STAFF REPORT

HEARING DATE: February 8, 2022

SUBJECT: [H-2021-0075](#); [CR-2022-0001](#)
Rackham East – AZ, PP
Eagle View Apartments – CUP, ALT, CR

LOCATION: South side of I-84, ¼ mile east of S. Eagle Rd., in the south ½ of Section 16, T.3N., R.1E.

B. Preliminary Plat (date: 10/25/2021)

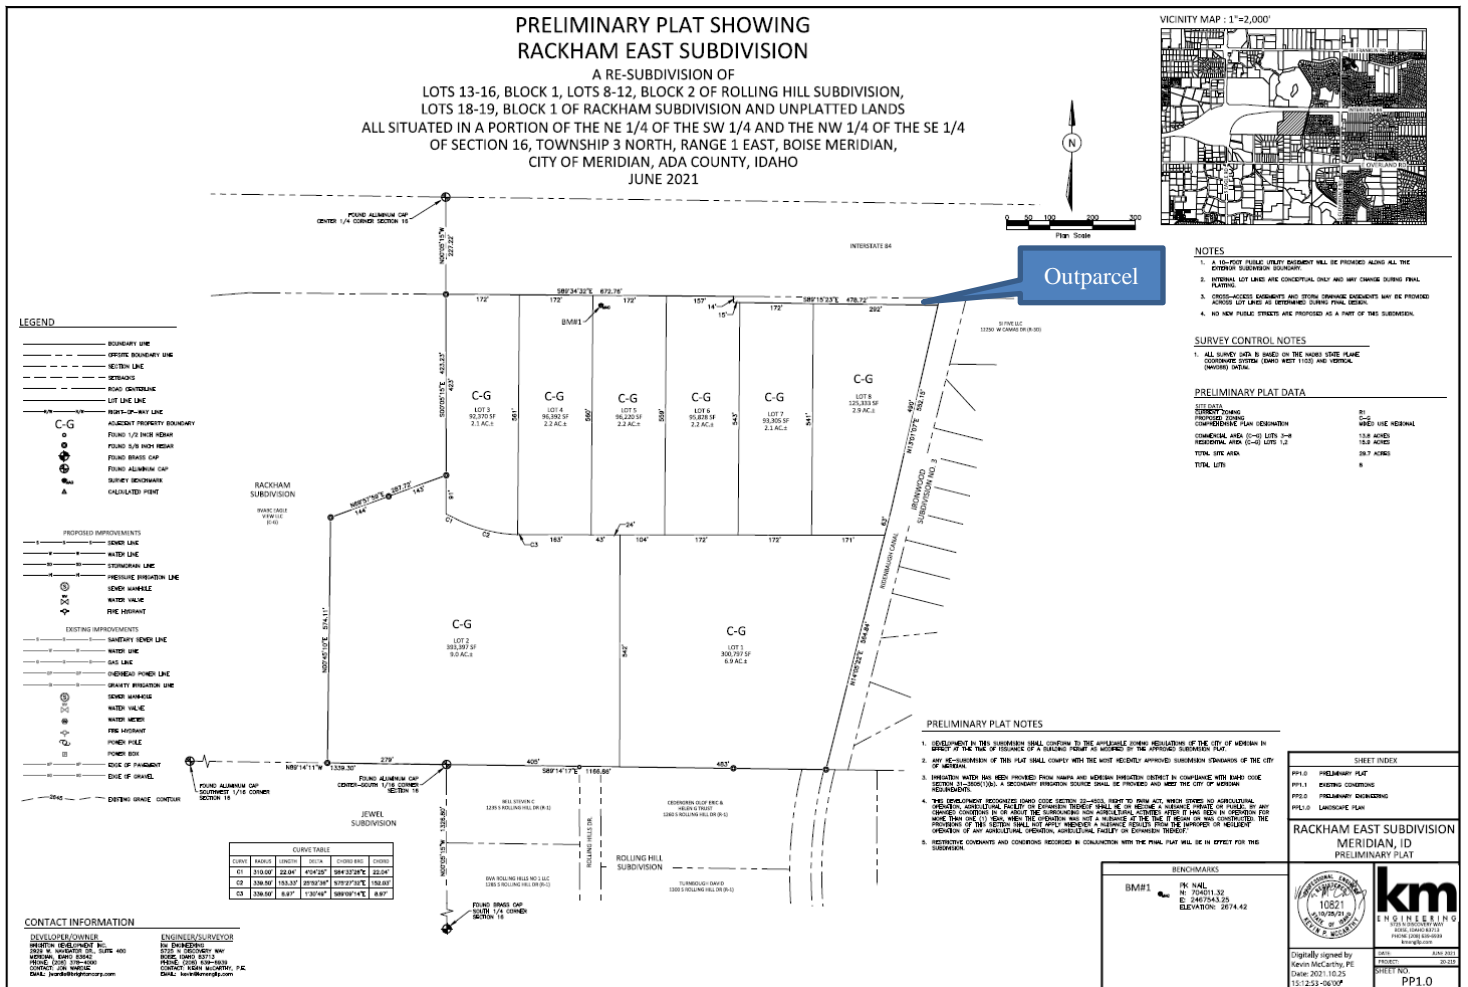
The proposed plat is a re-subdivision of Lots 18 and 19, Block 1, Rackham Subdivision No. 1 and Lots 8-12, Block 2 and Lots 13-16, Block 1, Rolling Hill Subdivision. The proposed plat consists of two (2) multi-family residential building lots (i.e. Lots 1-2, Block 1) and six (6) commercial building lots (i.e. Lots 3-8, Block 1) on 29.7 acres of land and is proposed to be developed in one phase. *Note: The Applicant anticipates that many of the commercial lots will be consolidated or realigned at the time of final plat as users determine precise site area requirements.*

Staff recommends the property is subdivided prior to application for any building permits for the site; or, the existing PUDI easements and right-of-way for S. Rolling Hill Dr. may be vacated and a property boundary adjustment application approved to consolidate the existing lots into one (1) parcel. Either method should be done prior to submittal of applications for building permits.

Note: There is a 14-foot wide sliver of land (Parcel #S1116427890) that exists to the north of the eastern portion of Lot 6 and Lots 7 and 8 that is not included in the proposed subdivision (see preliminary plat exhibit in Section VII.B). It appears to previously have been part of the right-of-way (ROW) for I-84 that was sold off as surplus ROW. It was not included as part of the adjacent building lots in the Rolling Hill Subdivision plat in 1968; therefore, Staff determines it to be an original parcel of record as defined in UDC 11-1A-1. As such, the subject property is deemed to be eligible for development without that parcel. However, Staff strongly urges the Applicant pursue obtaining the parcel and include it in this development; otherwise, there will be an undeveloped enclave with County zoning surrounded by City annexed land with no access and likely no maintenance of the property. Ideally, it would be included in the subject annexation and preliminary plat application, which would require re-noticing and a continuance of the hearing – Staff has suggested this to the Applicant but they wish to proceed without it as they continue trying to acquire the property. Since it is not included with this application, the applicant will have to submit a subsequent AZ application to the City for review and approval.

C. Landscape Plan – Preliminary Plat (date: 10/15/2021)

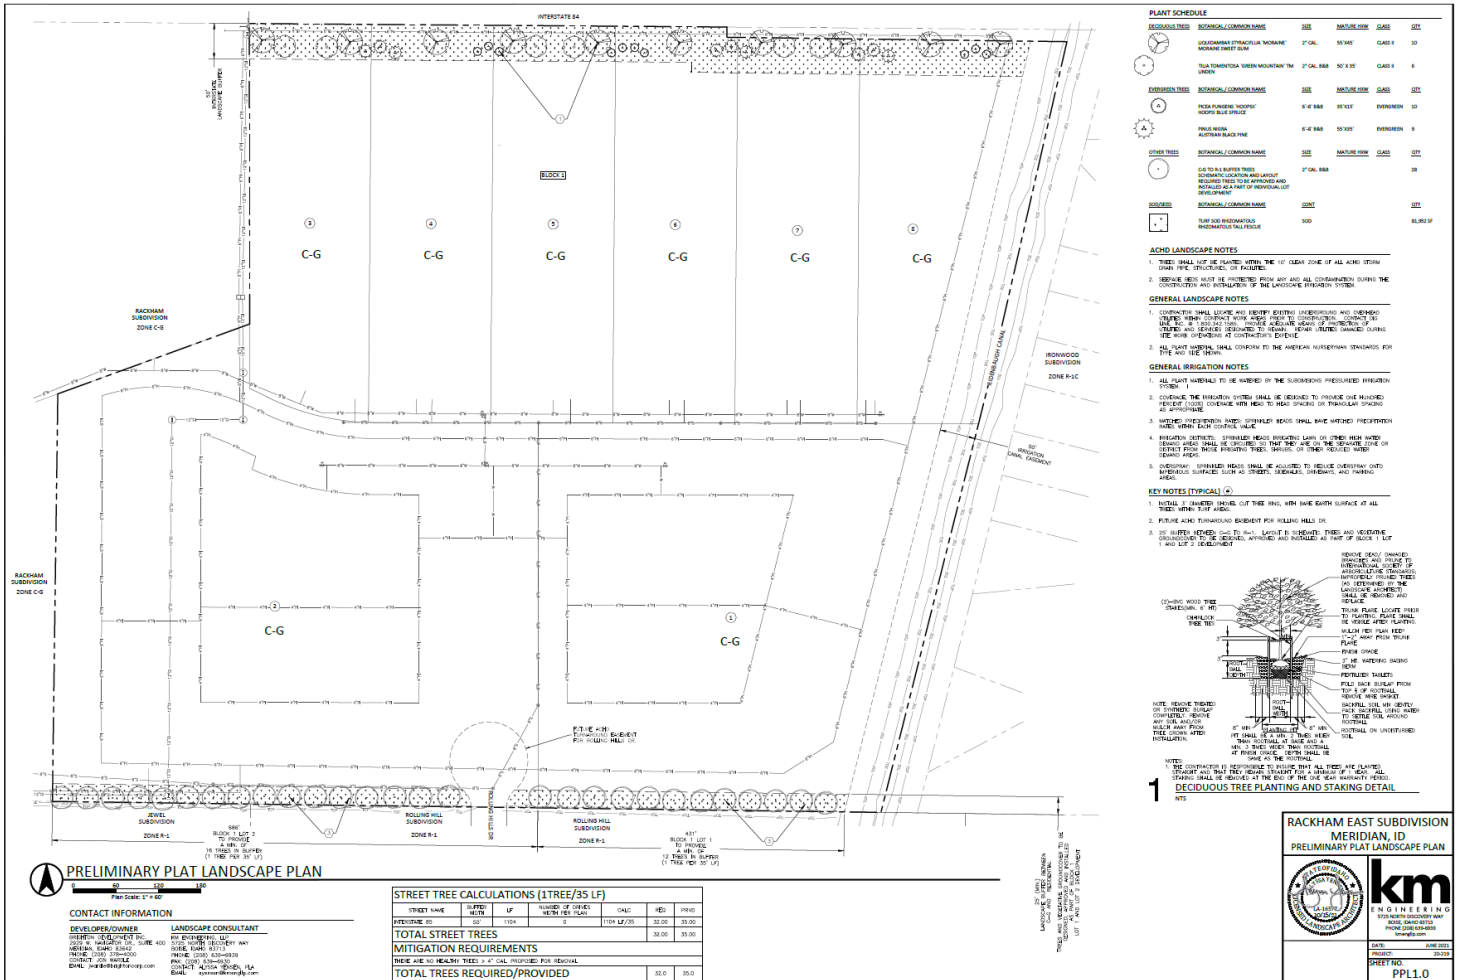
A 50-foot wide street buffer is required on Lots 3-6 along the north boundary of the site adjacent to I-84 per UDC [Table 11-2B-3](#), landscaped per the standards listed in UDC [11-3B-7C](#). The buffer depicted on the landscape plan complies with this standard. The street buffer is required to be maintained by the property owner or business owners' association per UDC [11-3B-7C.2b](#) and should be depicted on the plat in a common lot or permanent dedicated buffer.

Landscaping is required adjacent to the pathway proposed along the northern boundary of the site in accord with the standards listed in UDC [11-3B-12C](#). **A 5-foot wide landscape strip is required on both sides of the pathway planted with a mix of trees, shrubs, lawn and/or other vegetative ground cover.**

All fencing is required to comply with the standards listed in UDC 11-3A-7. Fencing is not depicted on the landscape plan; however, a 6-foot tall open vision wrought iron fence is proposed along the Ridenbaugh Canal to preserve public safety if Council approves a waiver to allow it to remain open and not be piped.

3. The landscape plan submitted with the final plat shall be revised as follows:
 - a. Depict a pathway within the street buffer along I-84 as shown on the CUP landscape plan with landscaping in accord with the standards listed in UDC 11-3B-12C. *A 5-foot wide landscape strip is required on both sides of the pathway planted with a mix of trees, shrubs, lawn and/or other vegetative ground cover.*

D. Conceptual Development Plan

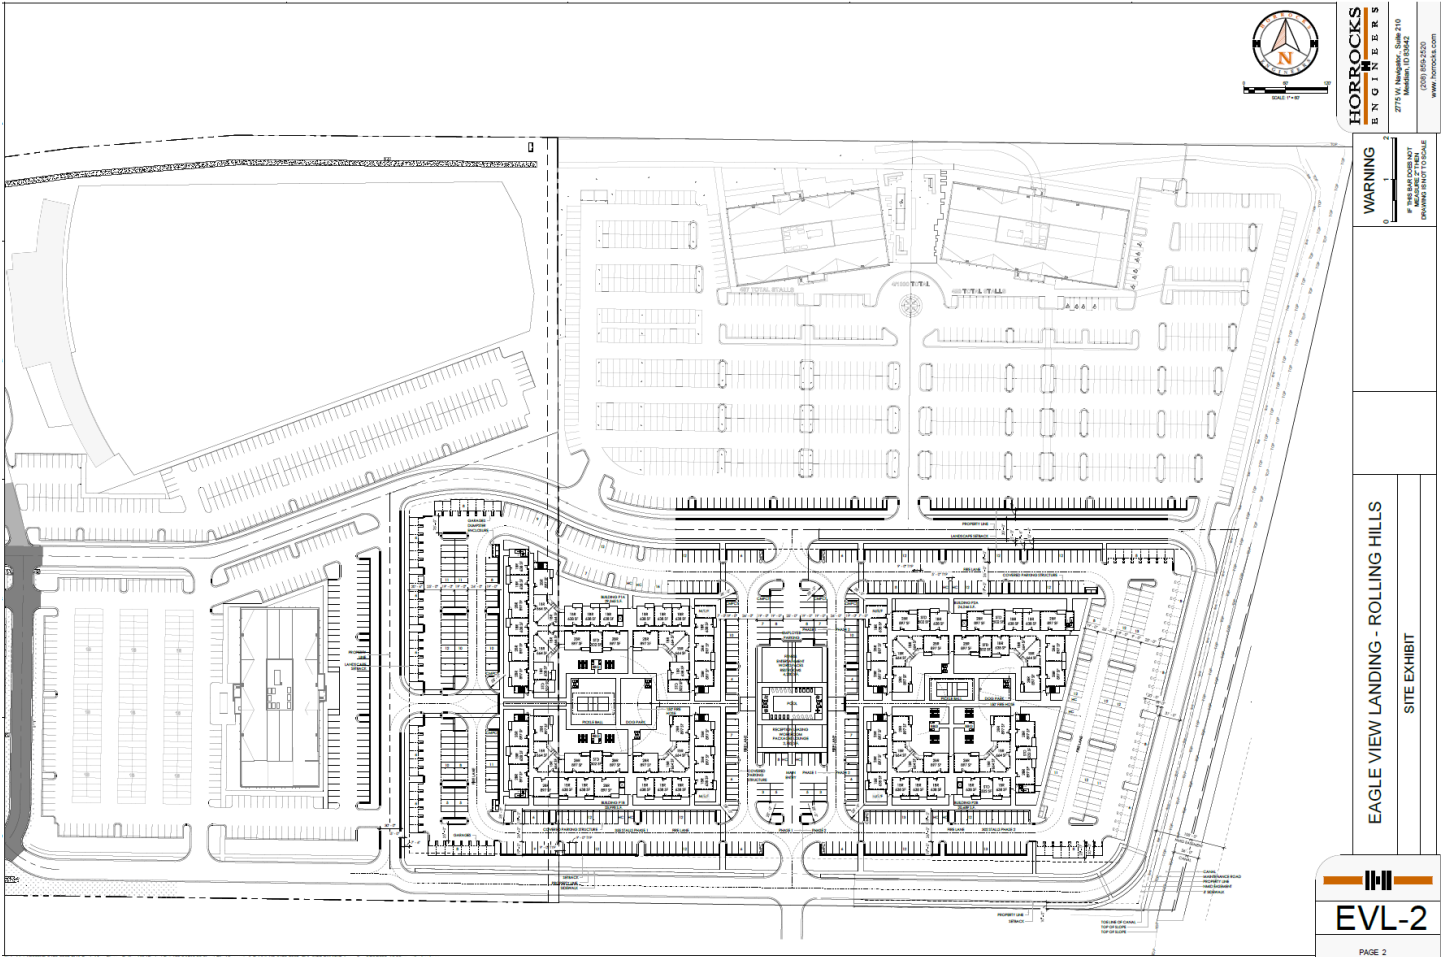
The conceptual development plan depicts a common area between the two office buildings that appears to meet this guideline; more details should be submitted on a site plan submitted for development of these buildings that comply with this guideline.

An outdoor gathering area is depicted on the conceptual development plan between the two office buildings on the northern portion of the site. Details should be submitted with development of these buildings that demonstrate compliance with this guideline.

The proposed conceptual development plan depicts a plaza/gathering area between the two office buildings on the northern portion of the site. A pedestrian circulation network, which will connect to the larger 90-acre Eagle View/Rackham development to the west, is proposed around the perimeter of the overall development as well as throughout the site that provide pedestrian connections to the multi-family development, office, retail, restaurant and hospitality uses within the development.

The conceptual development plan depicts a pathway within the street buffer along I-84. The pedestrian plan included in Section VII.H depicts internal pedestrian walkways throughout

- b. The two (2) office buildings proposed on the northern portion of the site shall be arranged to create some form of common, usable gathering area, such as a plaza or green space in accord with the mixed-use guidelines in the [Comprehensive Plan](#) (see pg. 3-13).

- c. Provide a pedestrian pathway within the street buffer along I-84 as depicted on the conceptual development plan with landscaping along the pathway as set forth in UDC [11-3B-12C](#). Also provide internal pedestrian walkways throughout the site for interconnectivity; where pedestrian walkways cross vehicular use areas they shall be distinguished through the use of pavers, colored or scored concrete, or bricks as set forth in UDC [11-3A-19B.4](#).

E. Site Plan – Conditional Use Permit (dated: ~~6/3/21~~ 1/6/22) & Phasing Plan

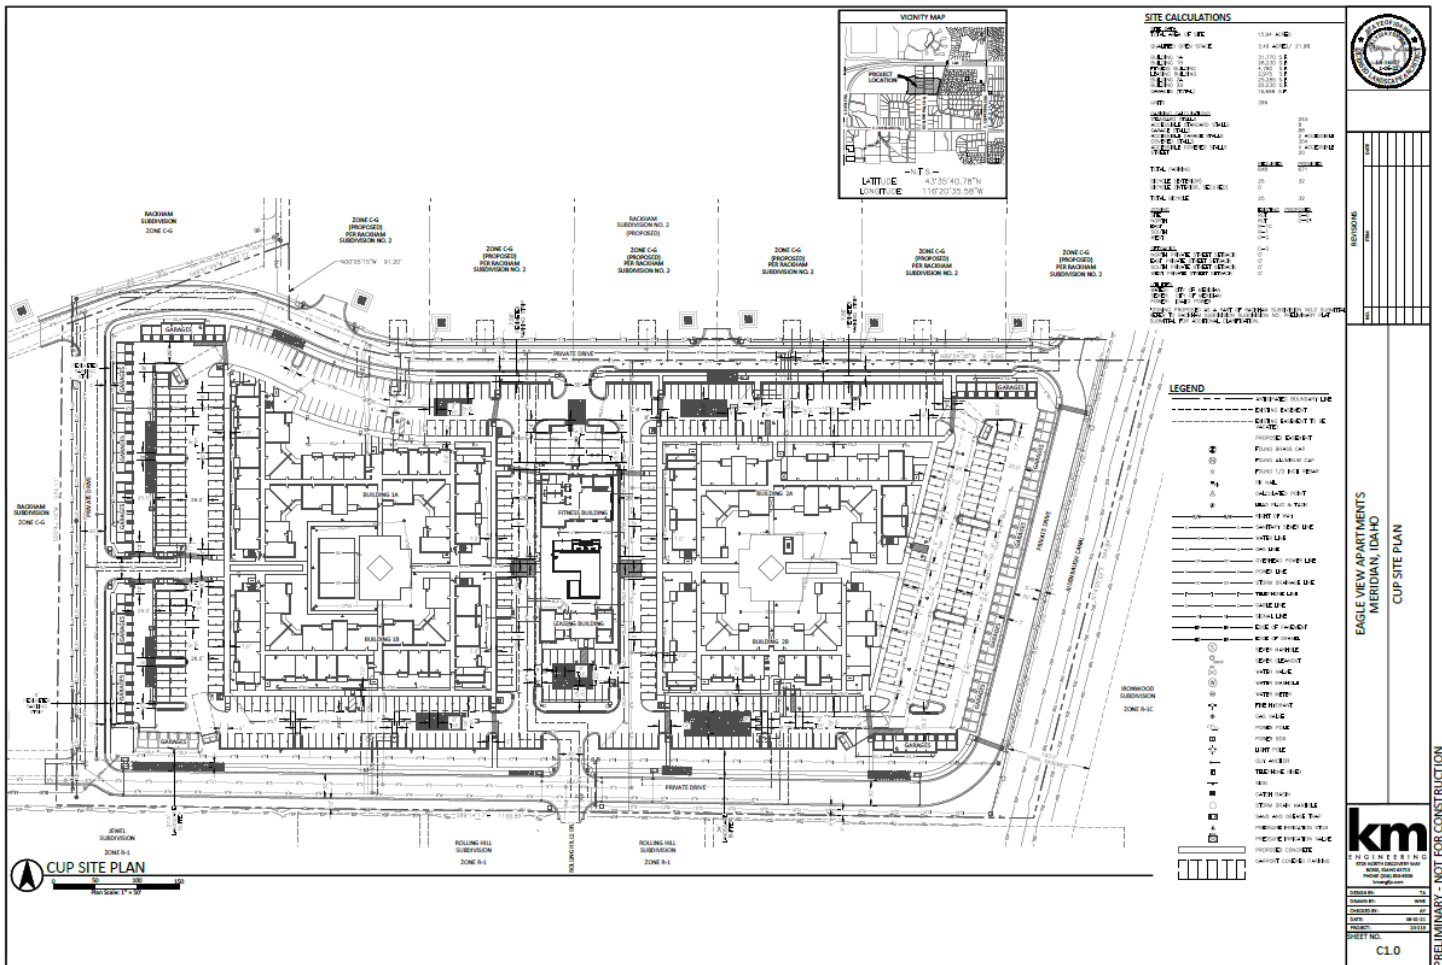
A minimum 25-foot wide buffer to residential uses is required with development along the southern boundary of the site per UDC Table 11-2B-3, landscaped per the standards in UDC 11-3B-9C, which requires a mix of evergreen and deciduous trees, shrubs, lawn, or other vegetative ground cover. **The buffer depicted on the landscape plan needs to be widened and additional landscaping depicted in accord with these standards.**

A total of ~~651~~ 651 off-street spaces are proposed on-site with ~~391~~ 398 of those being covered in garages (~~88~~ 90)/carports (~~303~~ 308); another 20 on-street spaces are proposed on the updated site plan along the future private street along the north boundary – these spaces can serve as guest parking but do not count toward the “off-street” parking requirement, ~~which includes compact spaces; compact stalls are discouraged but may be used for parking above the number of required parking spaces.~~ **Additional parking (5 spaces) should be provided to meet the minimum standards; the site/landscape plan submitted with the Certificate of Zoning Compliance application should be revised to reflect compliance.** *Note: The calculations on the landscape plan state 651 spaces are proposed, which differs from that on the site plan.*

Fencing: No fencing is depicted on the landscape plan for this development. A 6-foot tall open vision wrought iron fence is proposed along the Ridenbaugh canal to preserve public safety if Council approves a waiver to allow the canal to remain open and not be piped.

As an added buffer to the two adjacent rural residential properties to the south in Rolling Hill Subdivision, Staff recommends a 6-foot tall sight obscuring fence or wall is constructed along the southern boundary of the site.

- d. Depict the location of the property management office; maintenance storage area; central mailbox location, including provisions for parcel mail, that provide safe pedestrian and/or vehicular access; and a directory and map of the development at an entrance or convenient location for those entering the development in accord with UDC [11-4-3-27B.7](#).

- e. Depict a 6-foot tall sight obscuring fence or wall along the southern boundary of the site as an added buffer to the rural residential properties to the south in Rolling Hill Subdivision.
